Riley Purgatory Bluff Creek Watershed District Permit Application Review

Permit No: 2023-031

Project: Lake Susan Park Pond Reuse System Intake Modification – Modification of the existing pond water-reuse system and construction of a new intake structure and related piping and appurtenances.

To: Riley Purgatory Bluff Creek Watershed District
From: Barr Engineering Co.
Subject: RPBCWD Permit Submittal – Lake Susan Park Pond Reuse System Intake modification
Date: May 16, 2023
Project: 23270053.14 044

**LAKE SUSAN PARK POND
WATERSHED TREATMENT & STORMWATER REUSE
EXISTING CONDITIONS, REMOVALS, &
EROSION CONTROL PLAN**

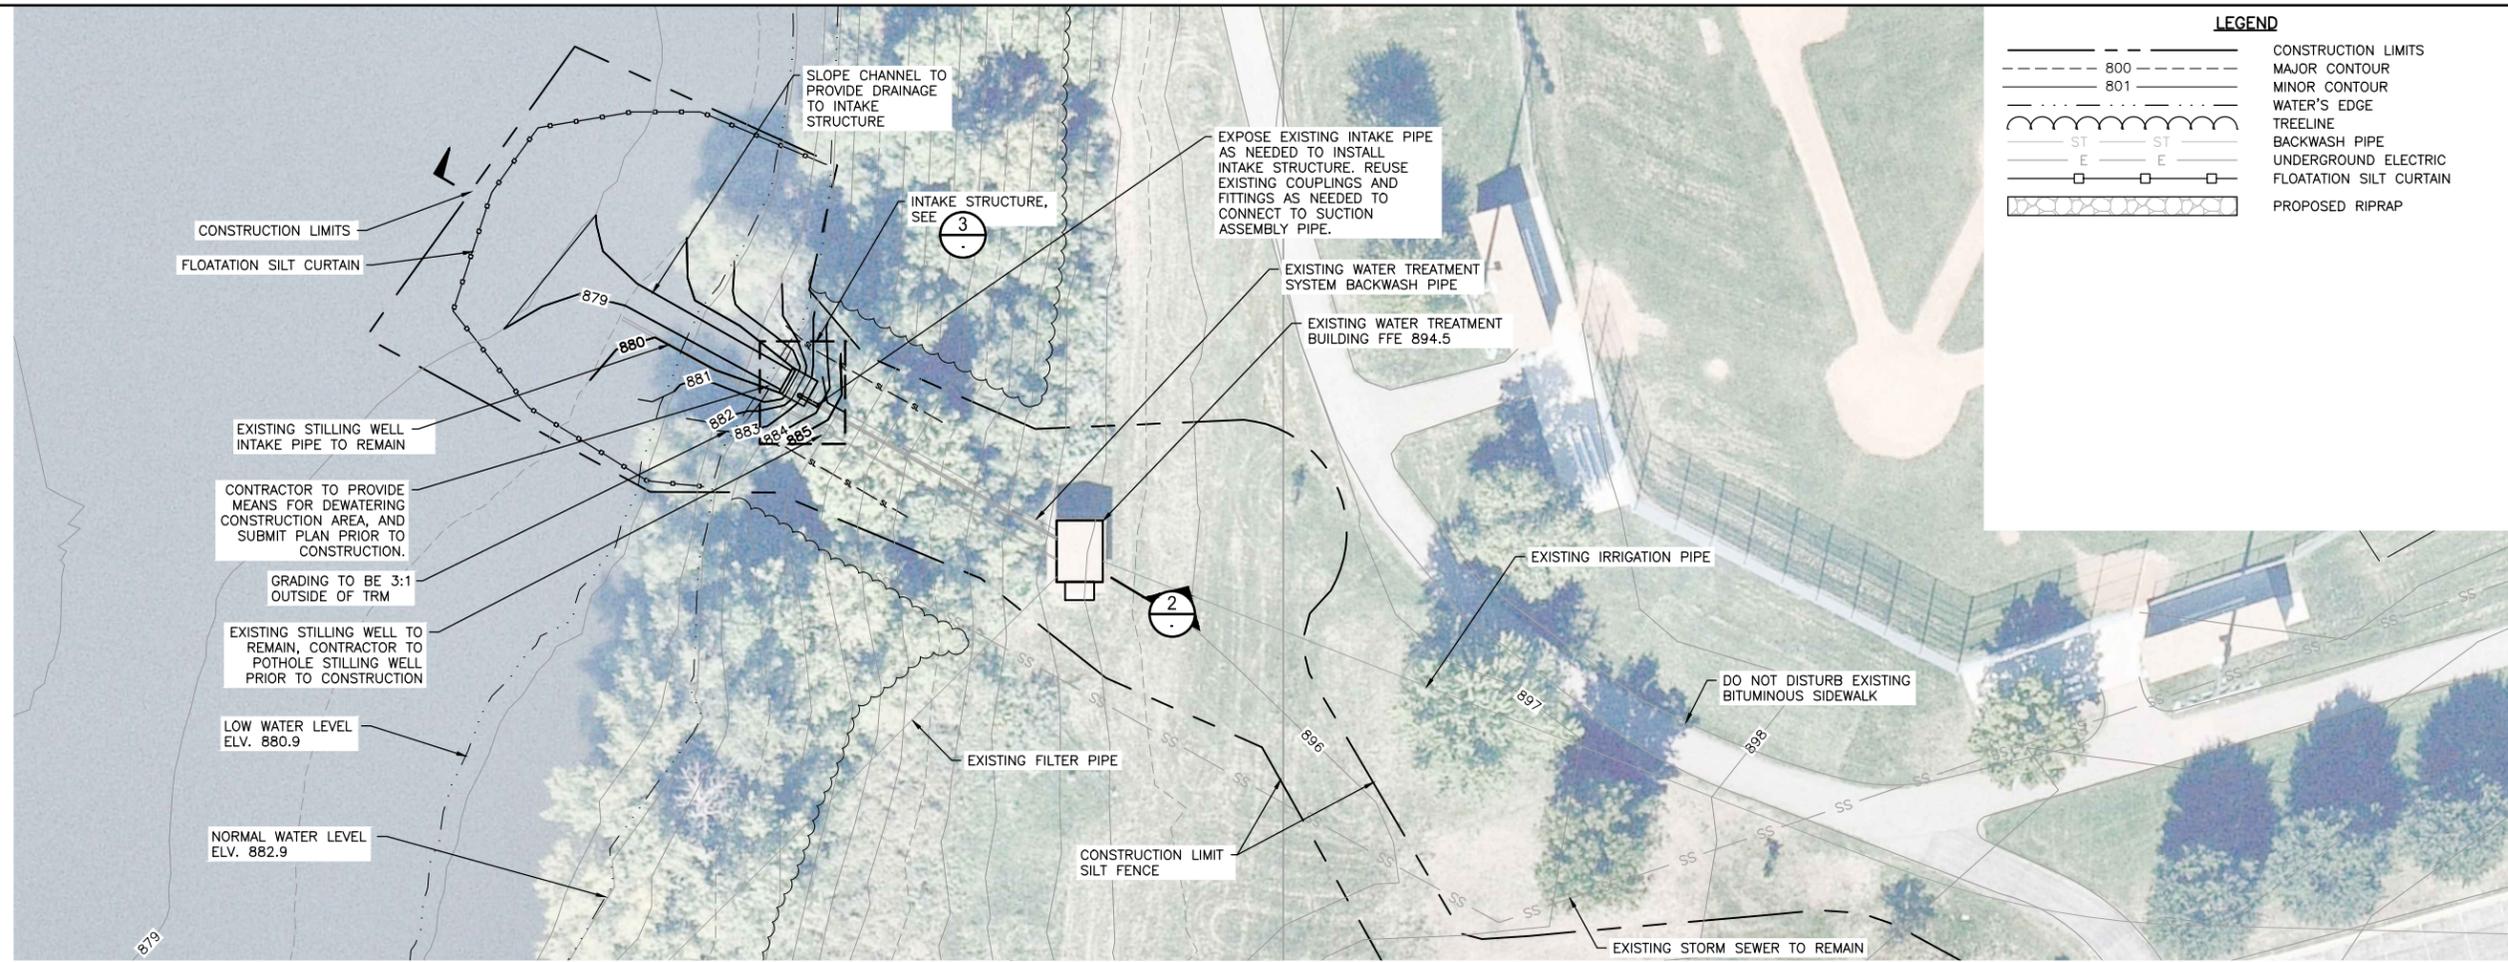
Because the applicant has demonstrated that the project will preserve the existing 100-year flood level, the project will not alter surface flows, complying with subsection 3.3. The information on the plan sheet includes a note indicating that the proposed activities must be conducted to minimize the potential transfer of aquatic invasive species conforming to Rule B, Subsection 3.6.

The erosion control/turf restoration plan includes installation of perimeter control measures such as biorolls, a construction access, floating silt curtain, turf establishment, daily inspection, placement of a minimum of 6 inches of topsoil, decompaction of areas compacted during construction, and retention of native topsoil onsite.

The erosion control/turf restoration plan includes installation of perimeter control measures such as biologs, a construction access, floating silt curtain, turf establishment, daily inspection, placement of a minimum of 6 inches of topsoil, decompaction of areas compacted during construction, and retention of native topsoil onsite. To conform to the RPBCWD Rule C requirements the following revisions are needed:

- C1. The Applicant must provide the name and contact information of the individual responsible for erosion control at the site. RPBCWD must be notified if the responsible individual changes during the permit term.

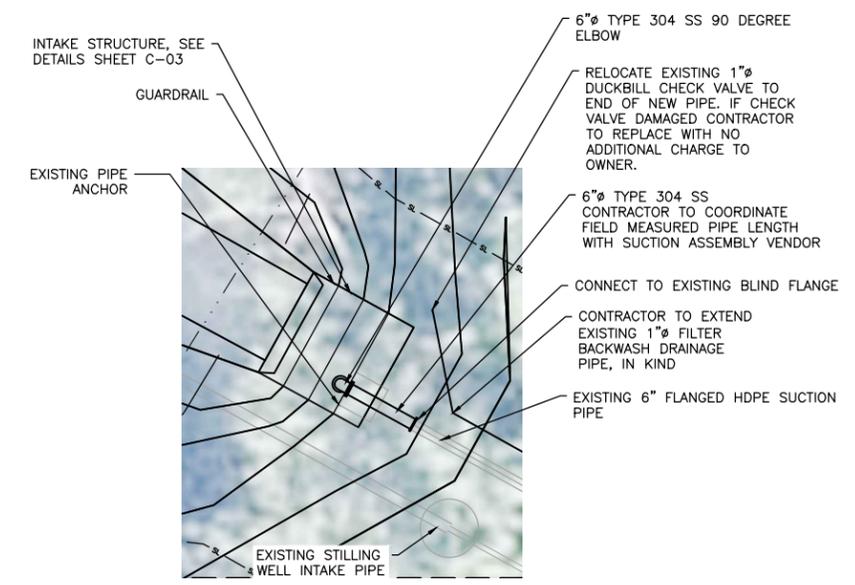
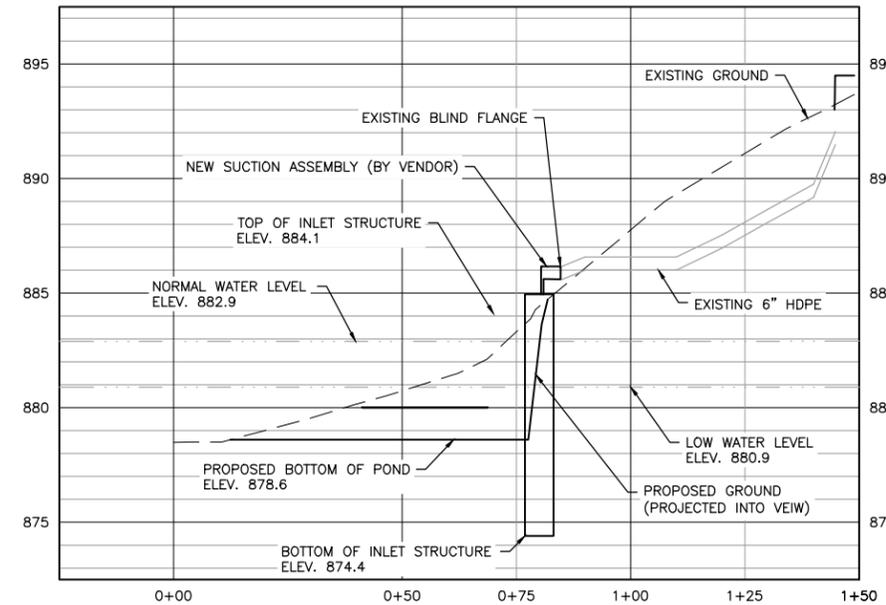
Because the grading plan illustrates that the 881 and 882 contours will be cut back into the existing grade (577 sf at elevation 881 and 138 sf at elevation 882) to produce an excavation or cut of about 357.5 cubic feet, the project results in a net increase in floodplain storage of 290.8 cubic feet. The supporting materials demonstrate, and RPBCWD staff concurs, that the project provides compensatory storage and conforms to Rule B, Subsection 3.2.

Because the grading plan illustrates that the 881 and 882 contours will be cut back into the existing grade (577 sf @ el 881 and 138 sf @ el 882) to produce an excavation or cut of about 357.5 cubic feet ($(577\text{sf} + 138\text{sf})/2 * 1\text{ft}$), the project results in a net increase in floodplain storage of 290.8 cubic feet. The supporting materials demonstrate, and the RPBCWD Engineer concurs, that the project provides compensatory storage and conforms to Rule B, Subsection 3.2.
